**TUALATIN ARCHITECTURAL REVIEW BOARD
FEBRUARY 6, 2017
POLICE TRAINING ROOM
8560 SW TUALATIN RD
TUALATIN, OR 97062**

SUBJECT: APPROVAL OF JUNE 10, 2015 ARB MINUTES

MINUTES OF June 10, 2015

LEGACY HEALTH MERIDIAN PARK PATIENT CARE EXPANSION

RECOMMENDED CONDITIONS

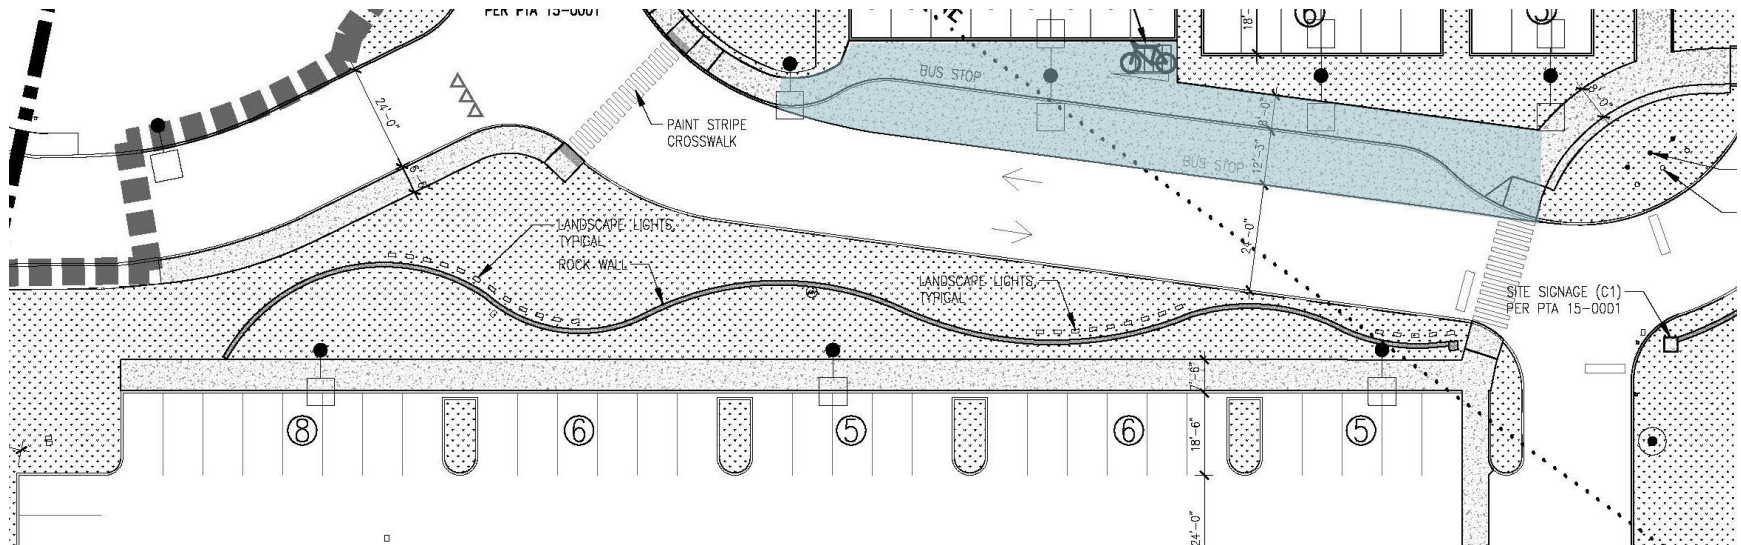
- **Pedestrian Circulation**
 - Conditions: AR-3, 4, 5, 6
- **Architectural Feature Review Elements:**
 - 6 ft wide walkways
 - Visibly raised walkways through parking area
 - Curb ramps
 - 8 ft wide accessway to connect walkways to abutting Arterial streets

REVIEW ELEMENTS: LANDSCAPING

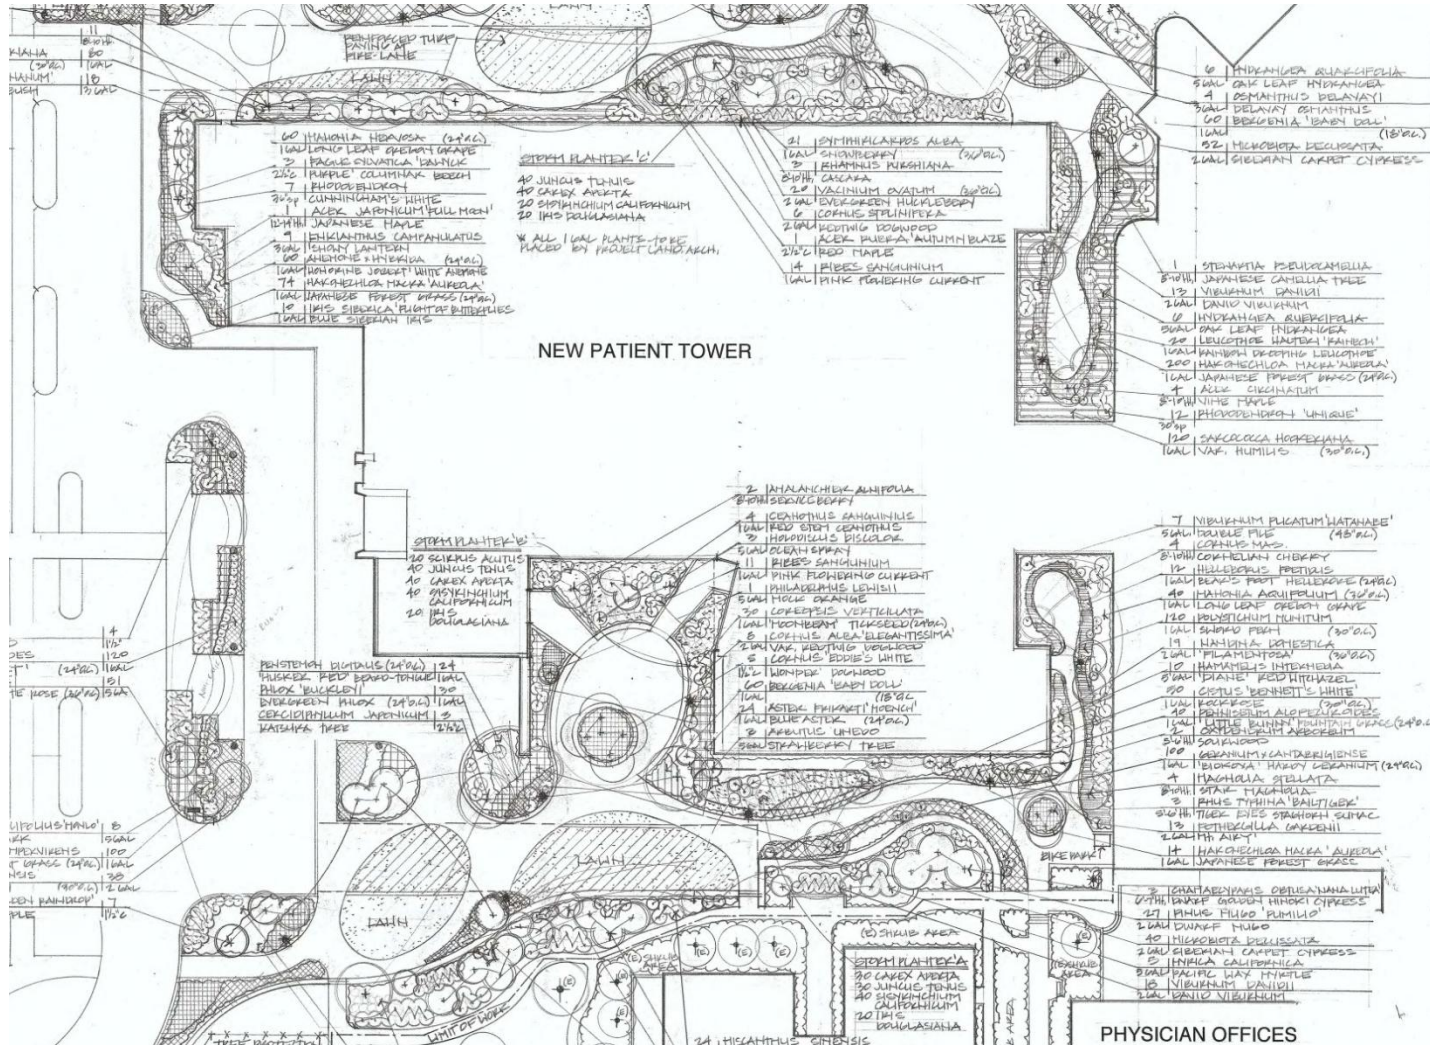
- **Landscaping**
 - Conditions: AR-10, 11, 12
- **Architectural Feature Review Elements:**
 - Proposed trees to meet minimum size requirements
 - Deciduous: 1.5” caliper
 - Coniferous: 5’ in height

- AR-11** The applicant shall revise Landscape Plan, Sheet L-1 (dated August 5, 2016) to reflect the total landscape area in either a table or with statistics that correspond to the landscape total presented on Proposed Site Plan, Sheet A-14 (dated October 17, 2016). Total landscape area shall meet the minimum requirements of 73.240(1)(4).

REVIEW ELEMENTS: BORLAND ROAD

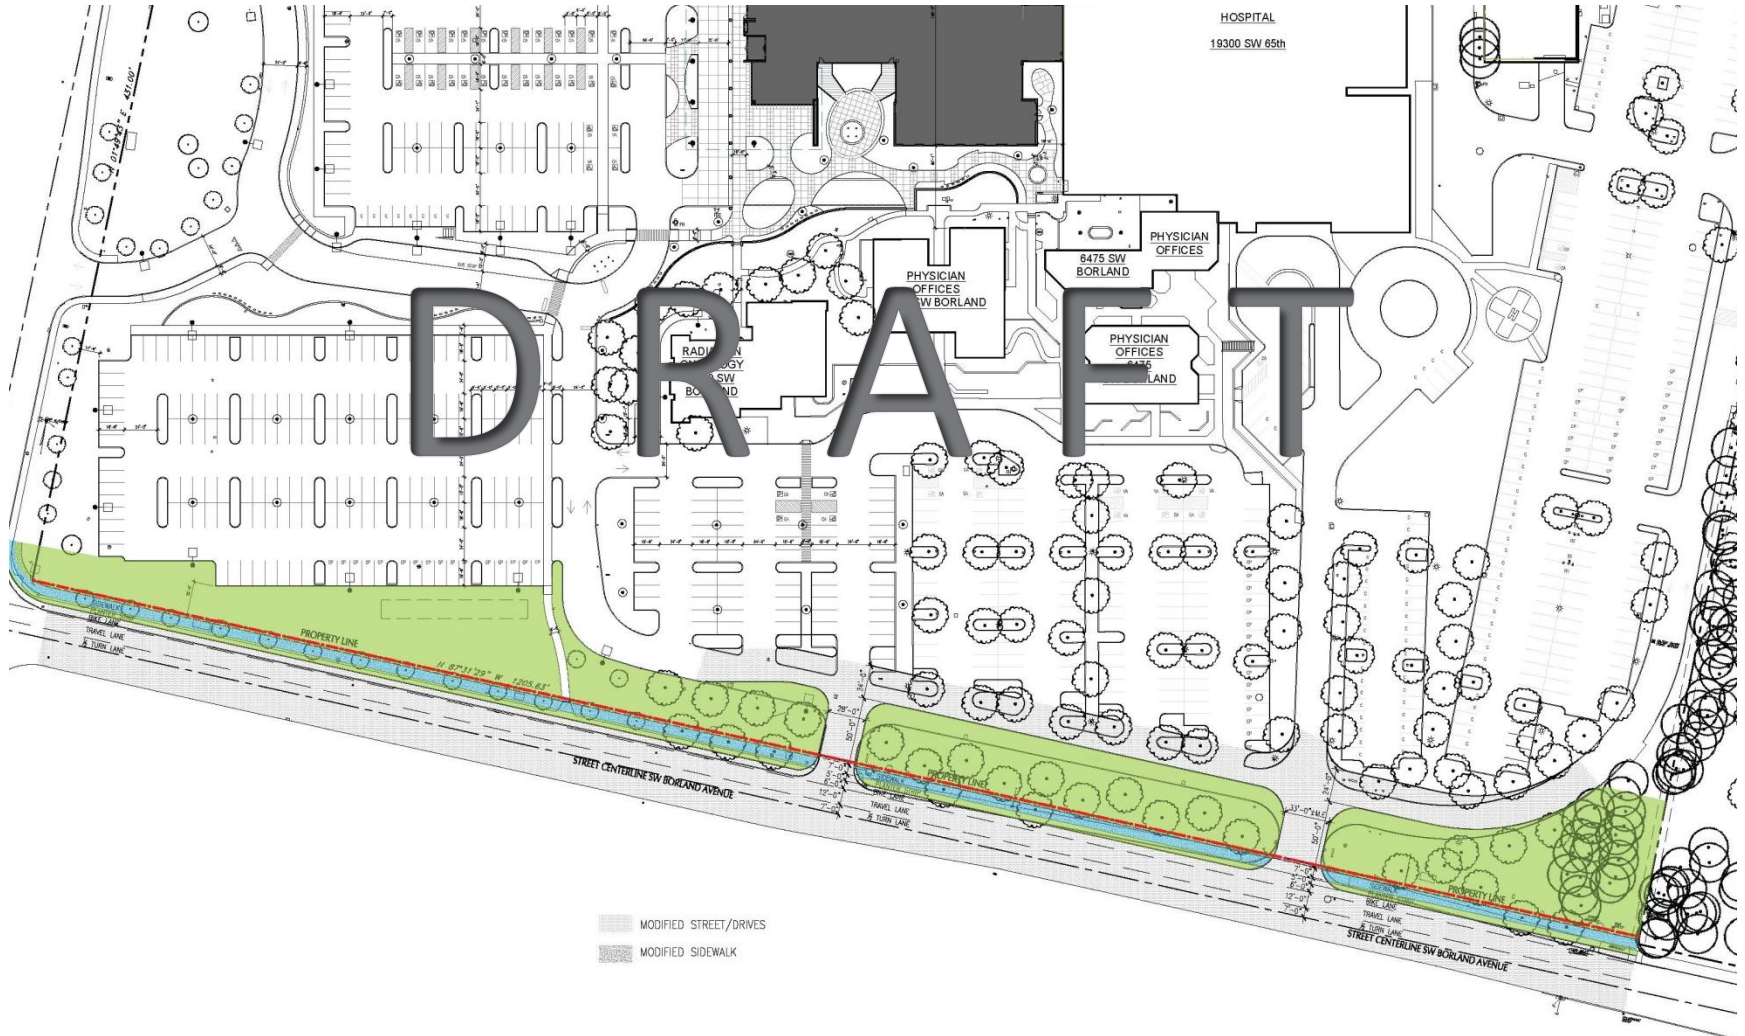
- **Site Revisions**
 - Condition: AR-13
- **Public Facilities Review Condition:**
 - Borland Road improvements to Clackamas Co. standards
- **Architectural Feature Review Elements:**
 - Potential impacts to: parking lot, landscaping, and tree mitigation

RECOMMENDED CONDITIONS

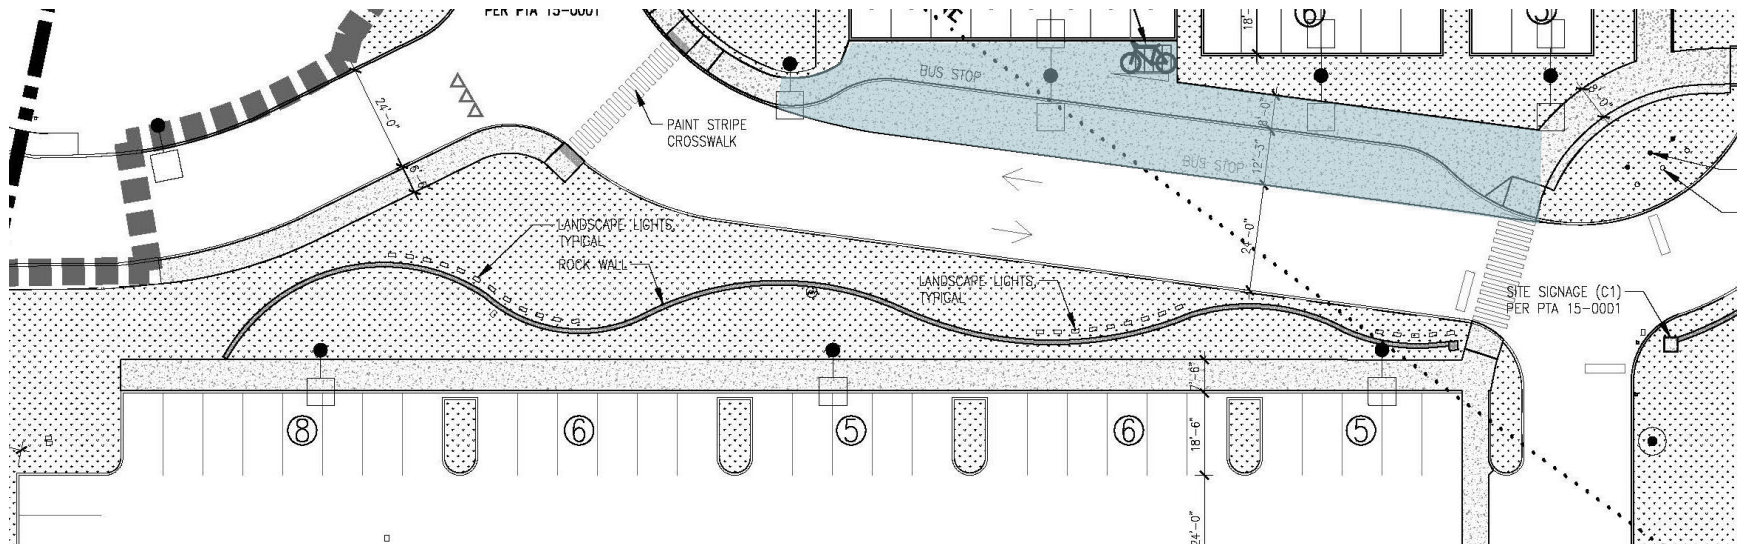
- **Pedestrian Circulation**
 - Conditions: AR-3, 4, 5, 6
- **Architectural Feature Review Elements:**
 - 6 ft wide walkways
 - Visibly raised walkways through parking area
 - Curb ramps
 - 8 ft wide accessway to connect walkways to abutting Arterial streets

REVIEW ELEMENTS: LANDSCAPING

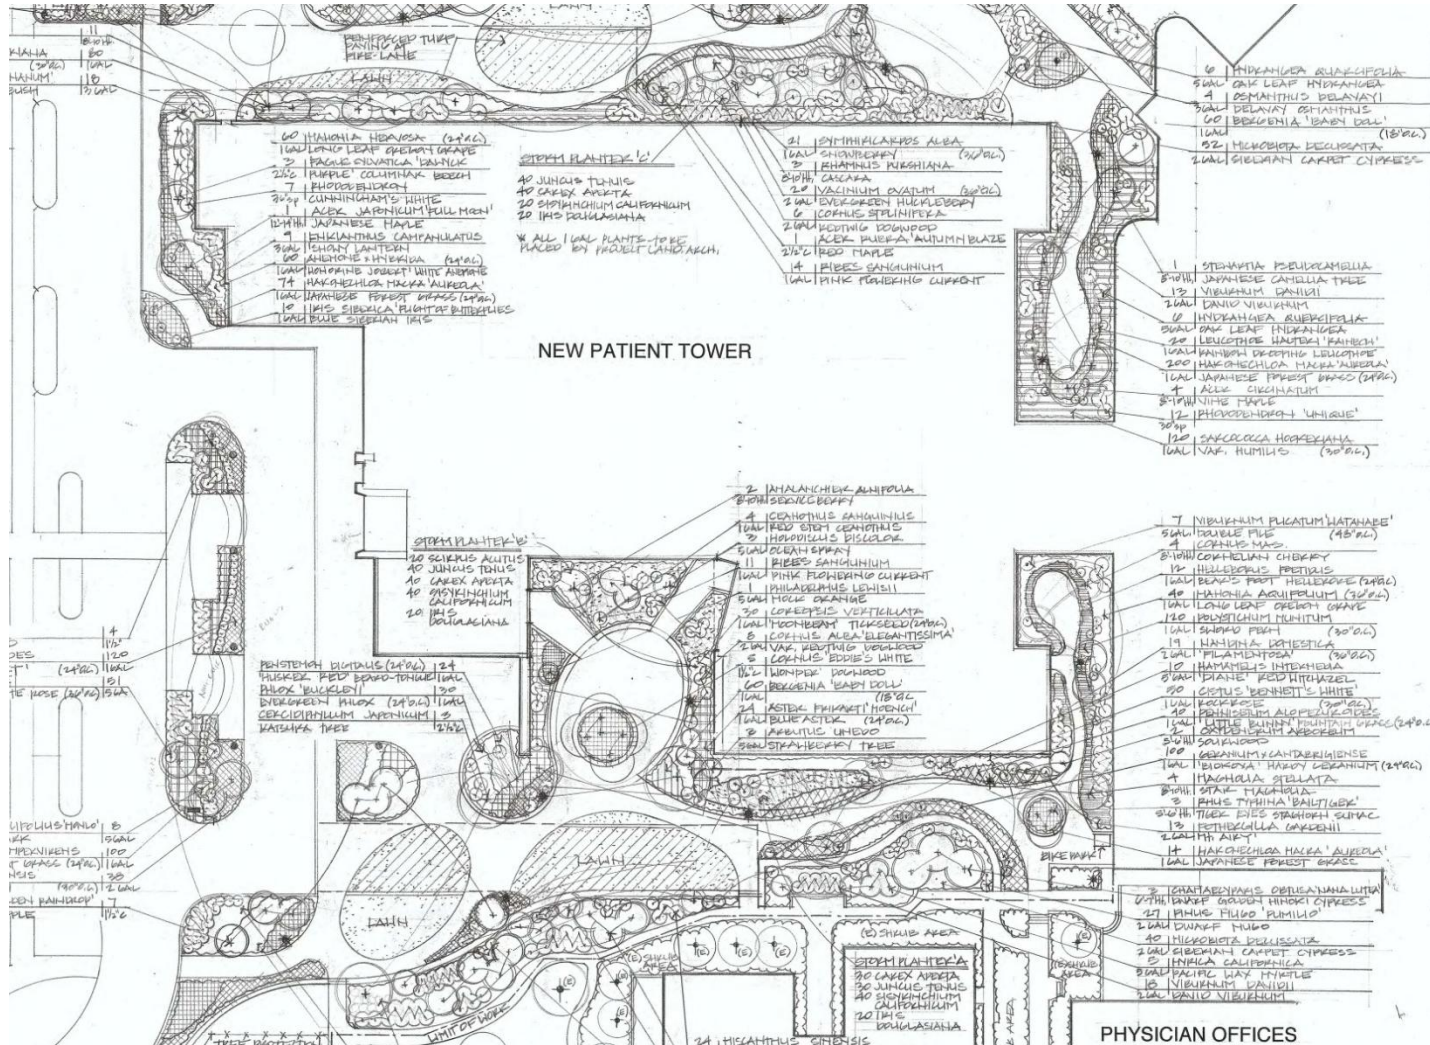
- **Landscaping**
 - Conditions: AR-10, 11, 12
- **Architectural Feature Review Elements:**
 - Proposed trees to meet minimum size requirements
 - Deciduous: 1.5” caliper
 - Coniferous: 5’ in height

REVIEW ELEMENTS: BORLAND ROAD

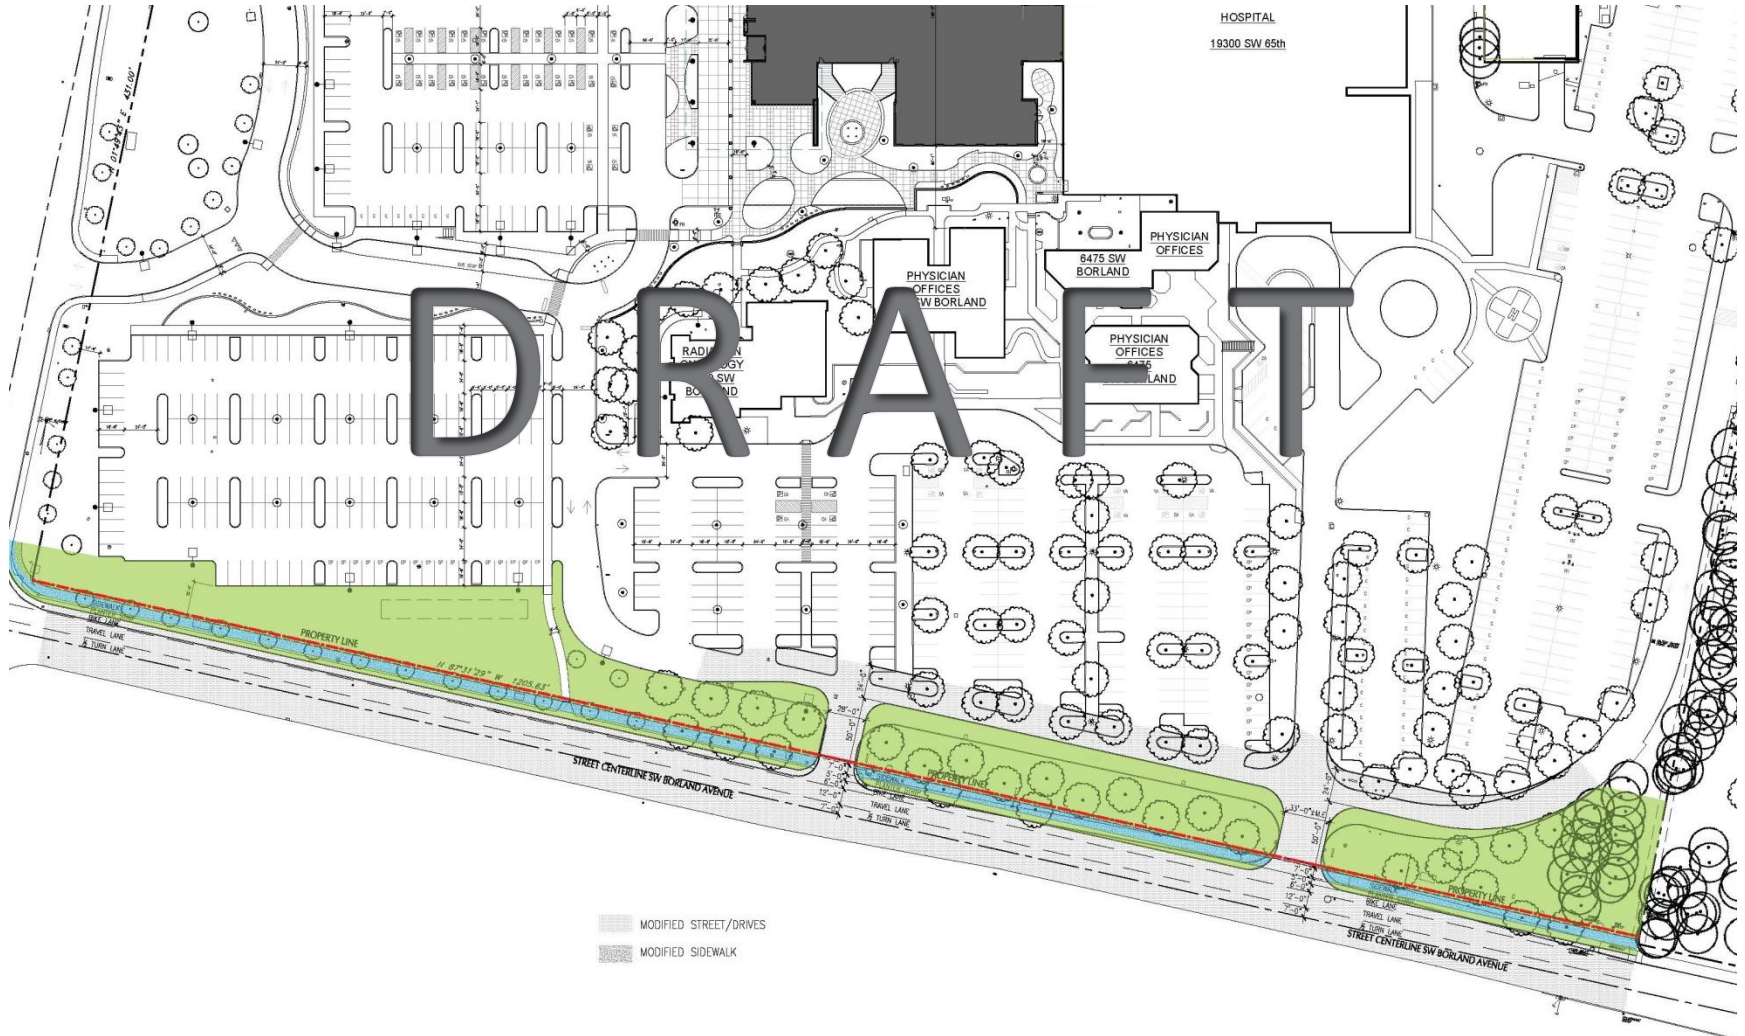
- **Site Revisions**
 - Condition: AR-13
- **Public Facilities Review Condition:**
 - Borland Road improvements to Clackamas Co. standards
- **Architectural Feature Review Elements:**
 - Potential impacts to: parking lot, landscaping, and tree mitigation

REVIEW ELEMENTS: BIKE PARKING

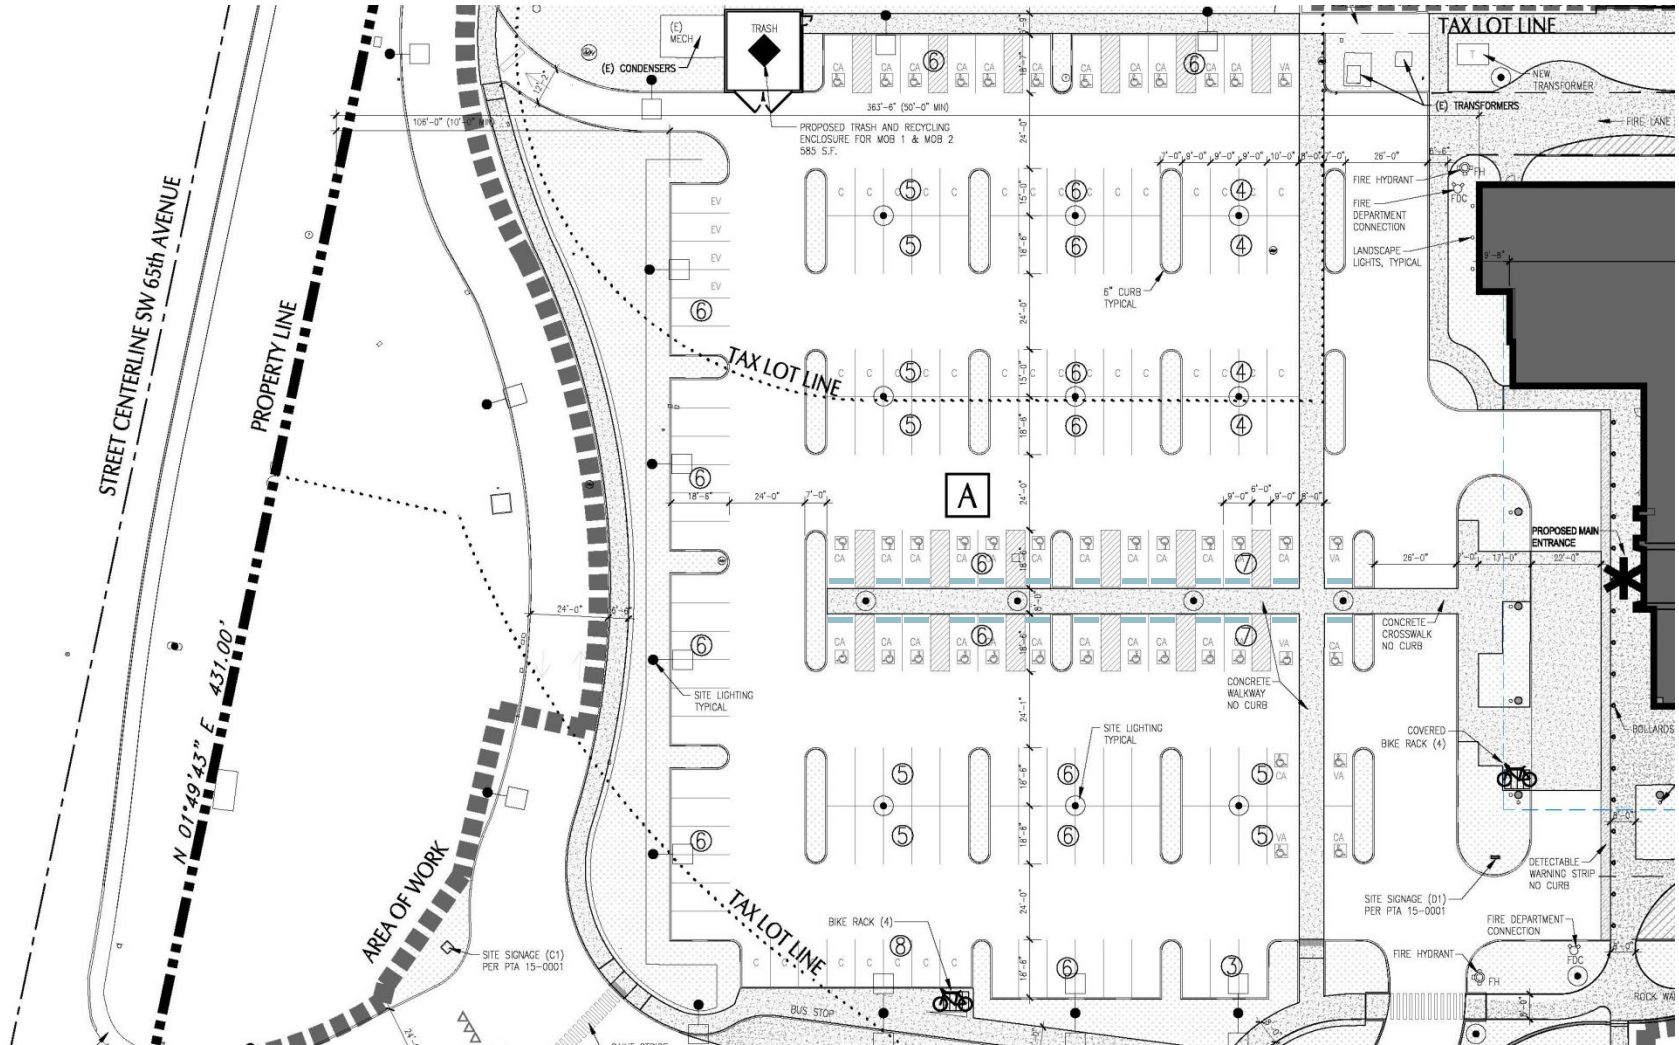
- **613 bike stalls required by Code**
 - TDC 73.370(1)(n) allows applicant to demonstrate why fewer bike stalls are sufficient
- **Applicant Response:**
 - 27 bicycle stalls are available for staff and patient use
 - Unlikely that patients would arrive by bike
 - 2014 Trimet employee commute survey: 2 trips reported; adjusted to 5
 - Current bike parking used: 7-19%
 - Proposed additional: 32% increase in floor area
 - If commuters tripled: 15 stalls needed
- **Staff recommends approval of reduced bike parking requirement**
